COUNTY OF SAN MATEO PLANNING AND BUILDING

SUBJECT: Coastside Design Review Recommendation

Columbus Street, El Granada

APN 047-275-060; County File No. PLN 2017-00002

MATERIAL PALETTE FOR COLUMBUS AVENUE, HALF MOON BAY, CA

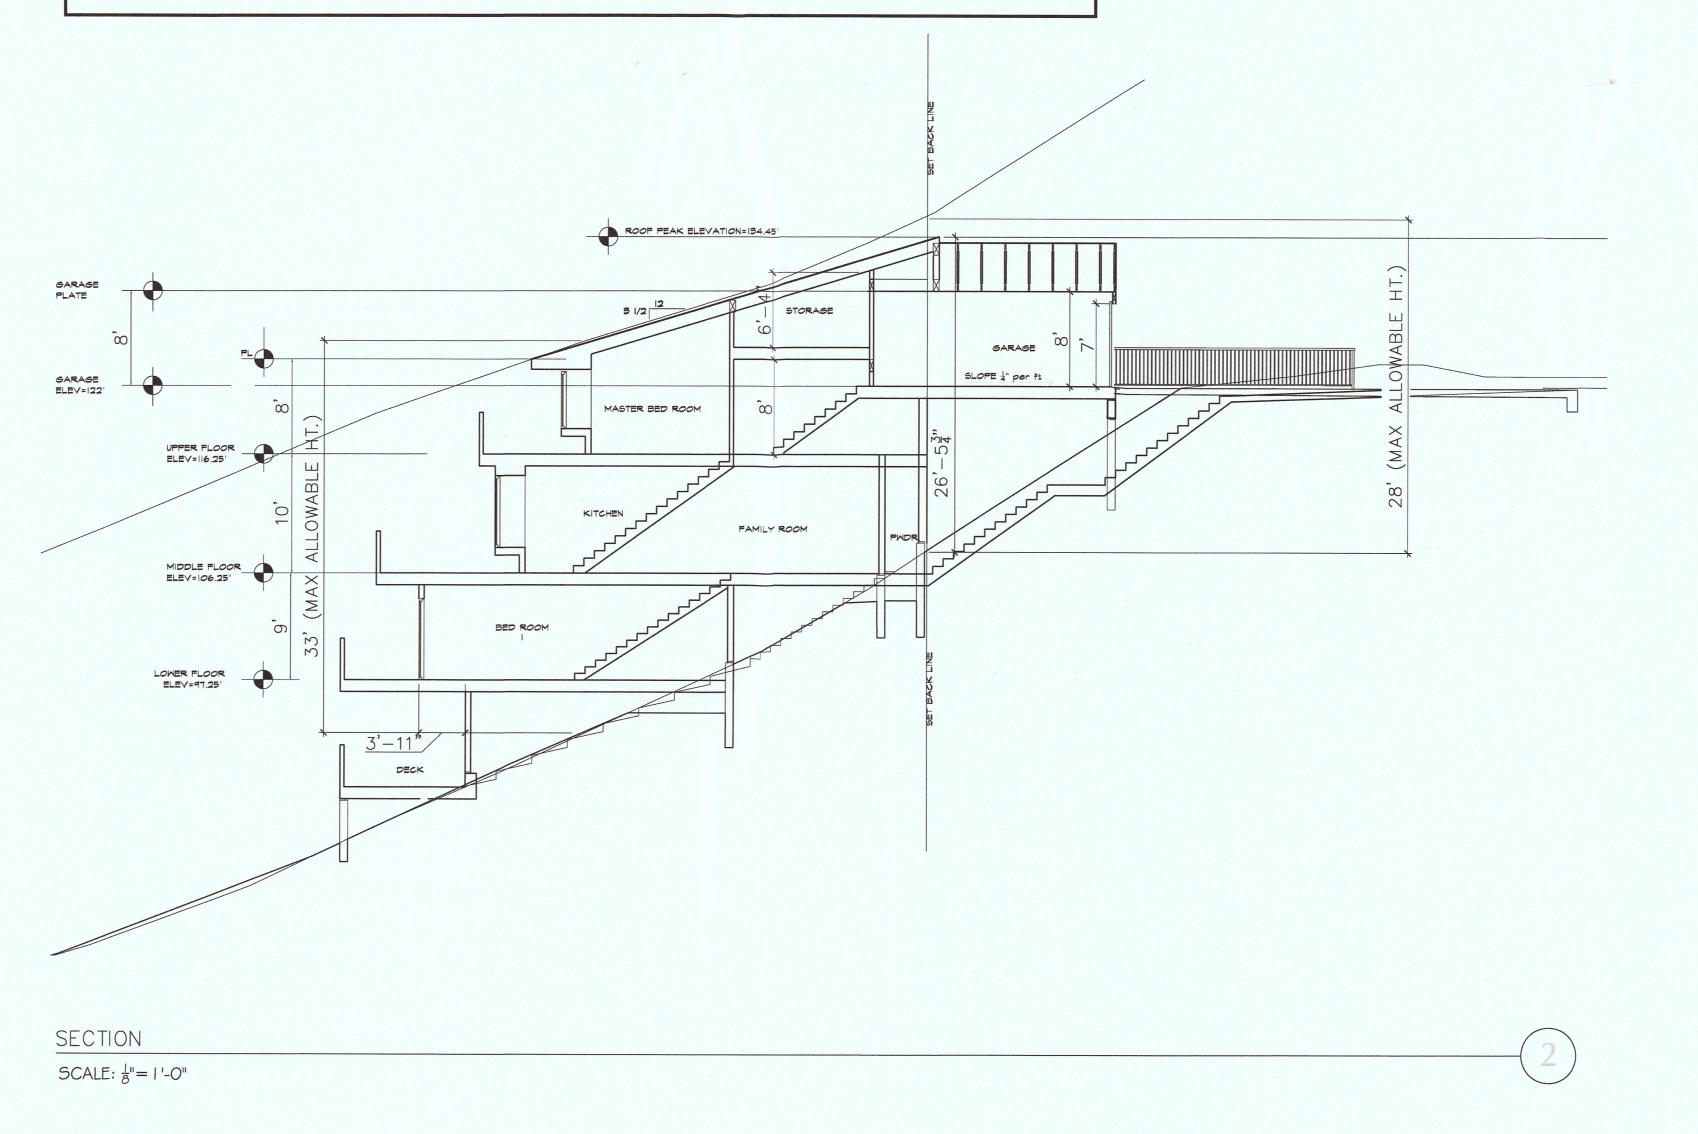
- b. Section 6565.20(D). ELEMENTS OF DESIGN; 4. Exterior Materials and Colors; Standards a.(2): Provide an additional paint color for increased contrast.

SITE PLAN SECTION

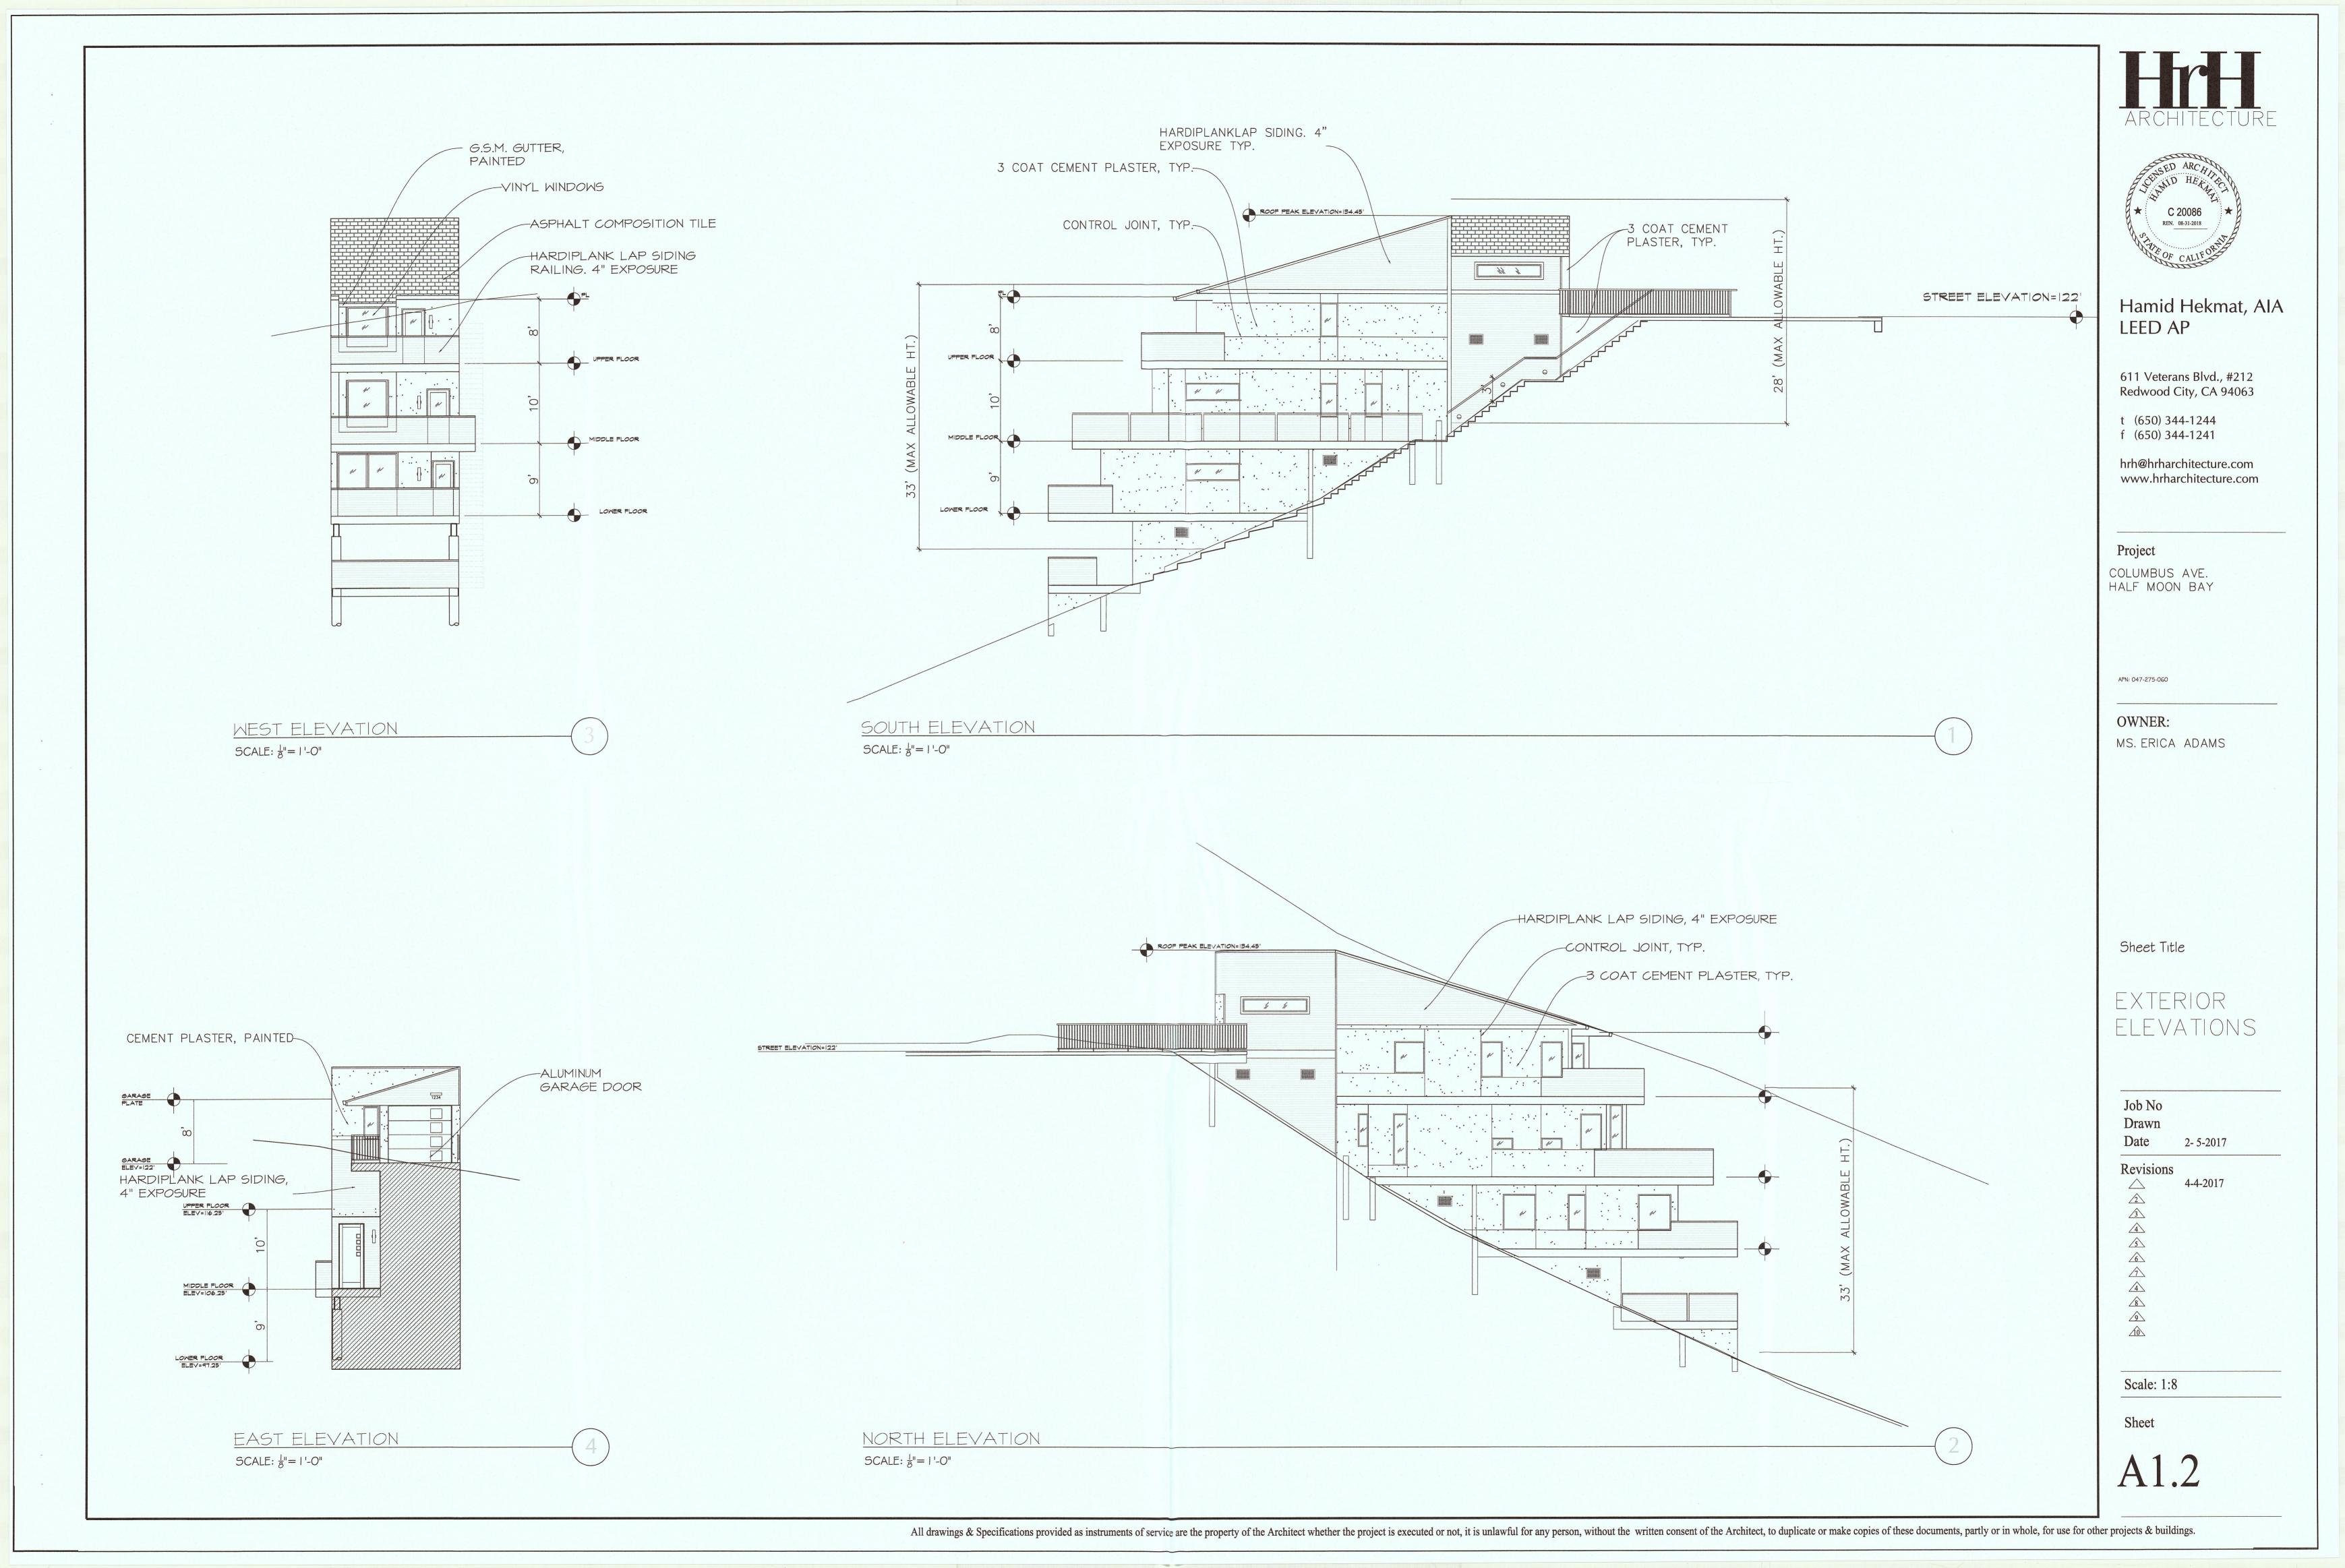
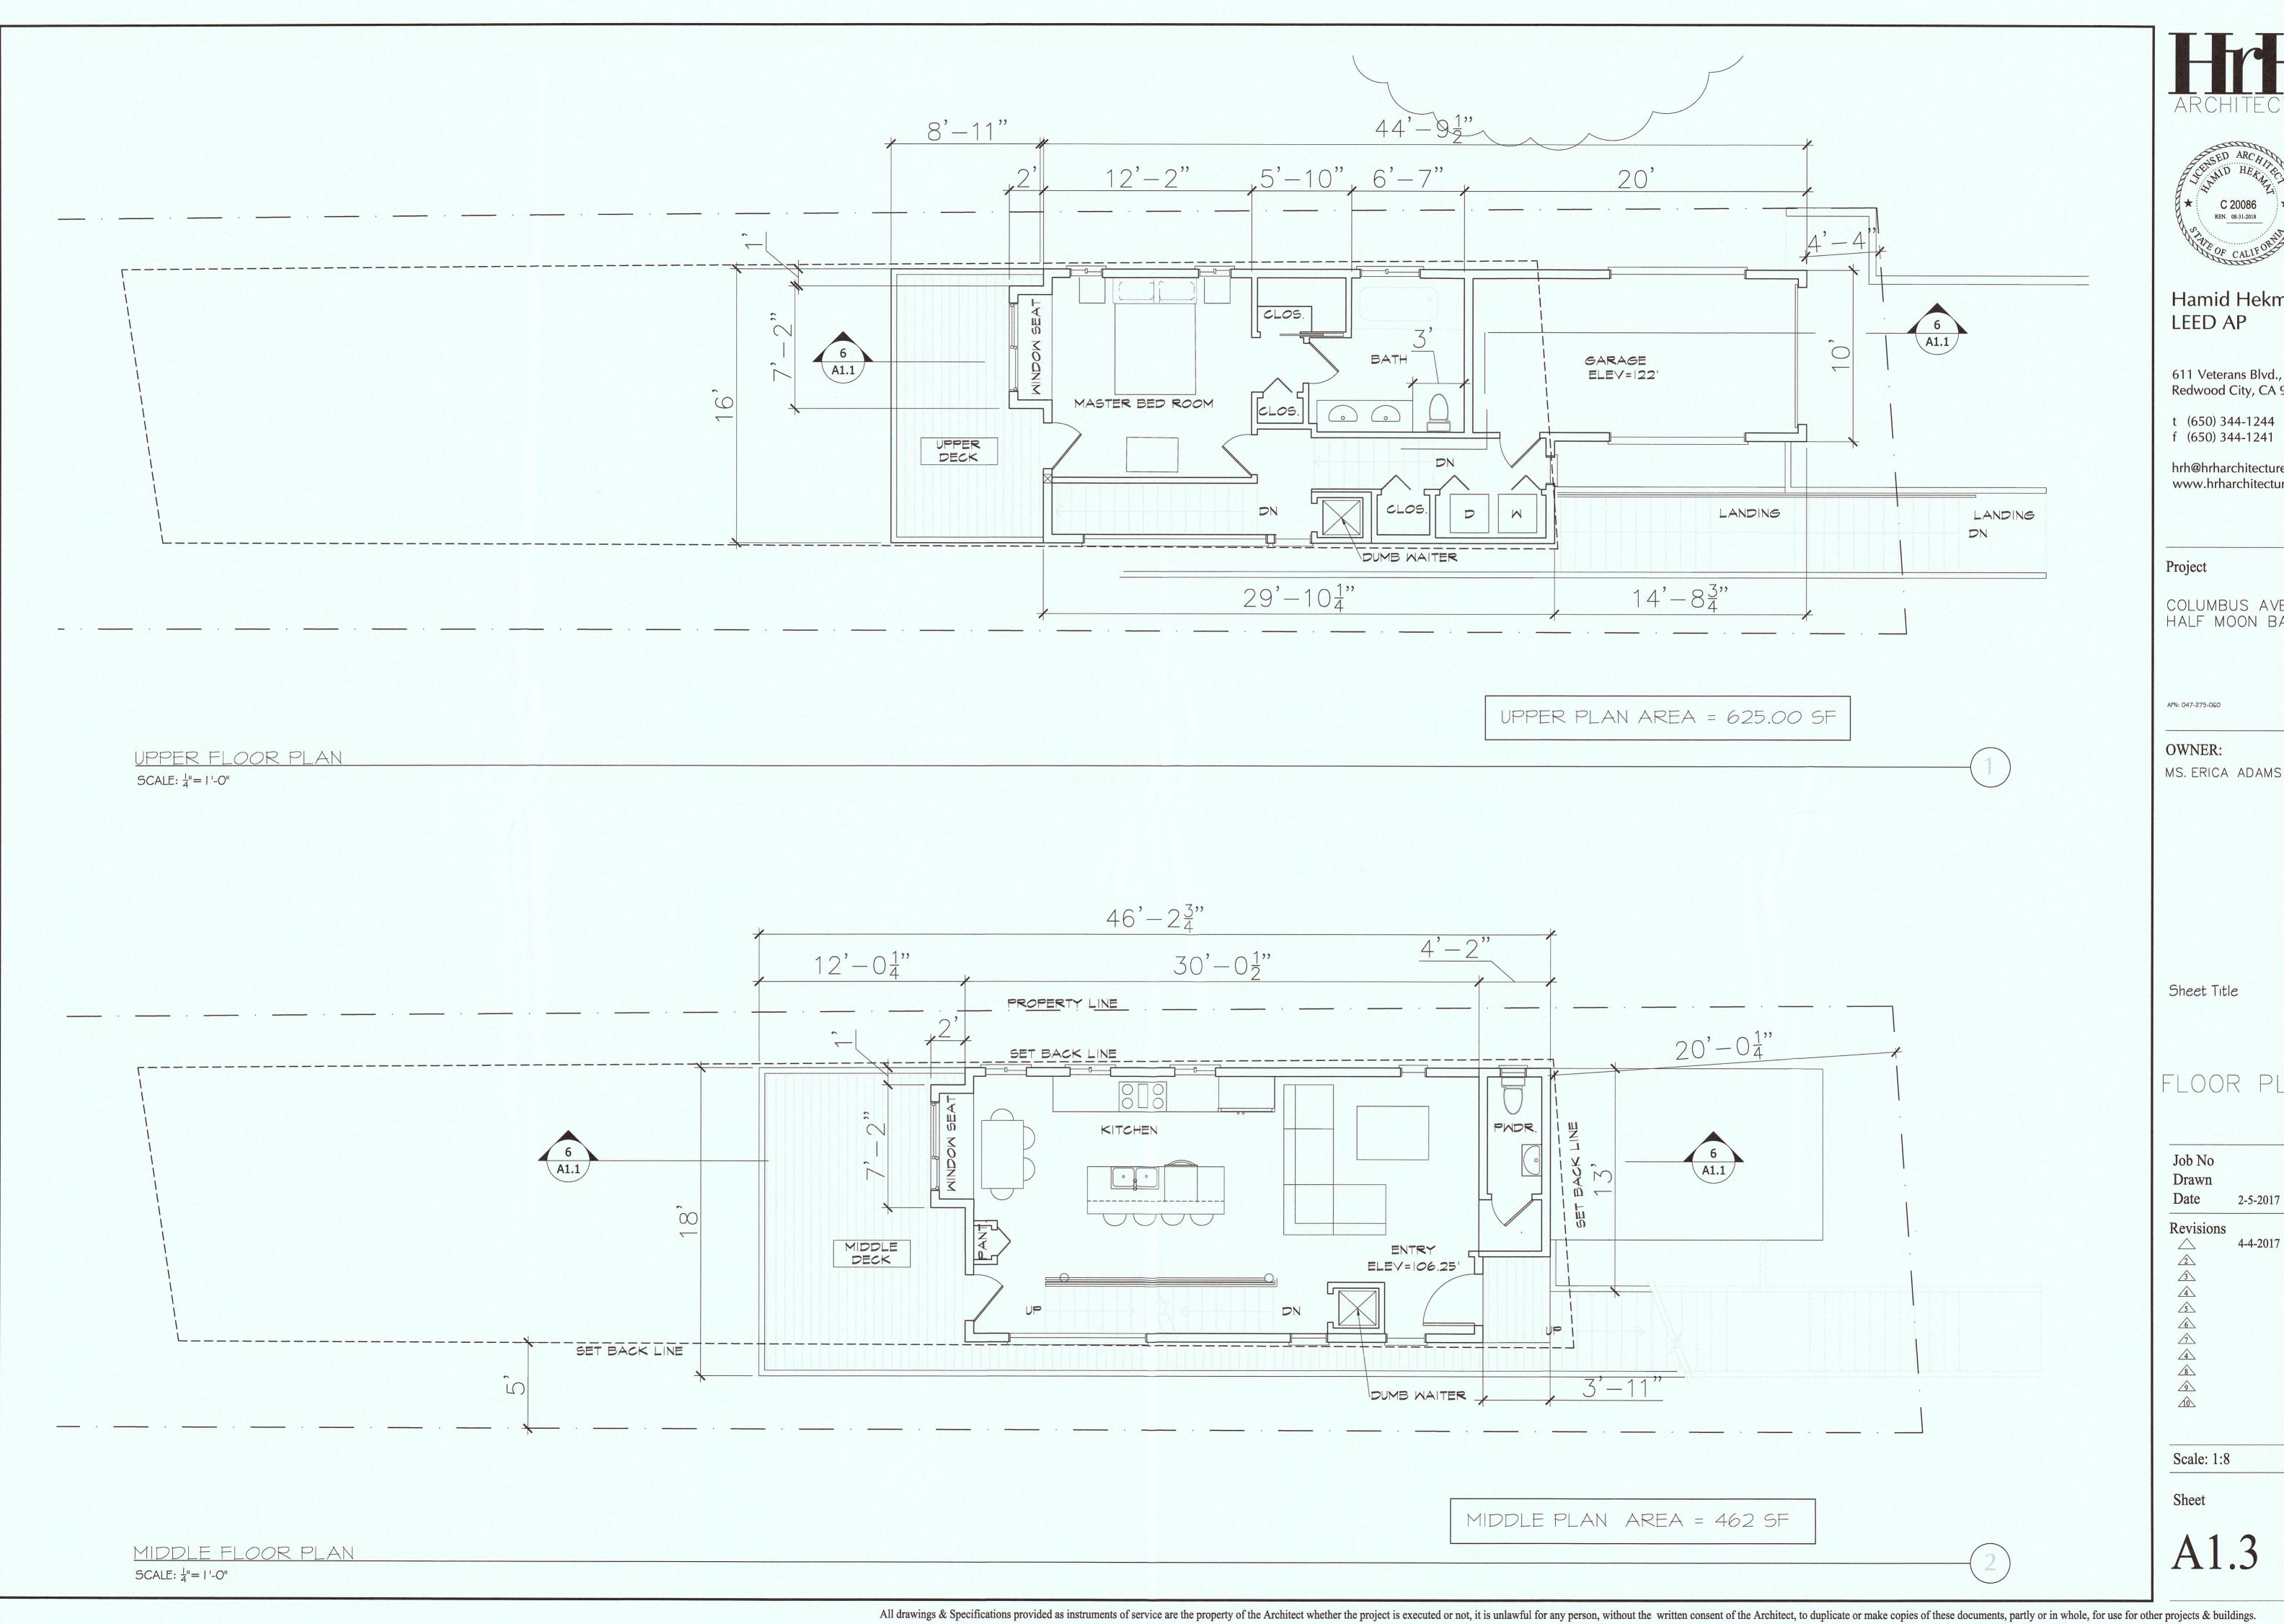
- c. Section 6565.20(D). ELEMENTS OF DESIGN; 1. Building Mass, Shape and Scale; a. Relationship to Existing Topography; Standards (2) and (3): Increase the terracing of balconies with regard to their relationship to the topography of the site. Minimize the unused space under the lower level and middle level of the house.
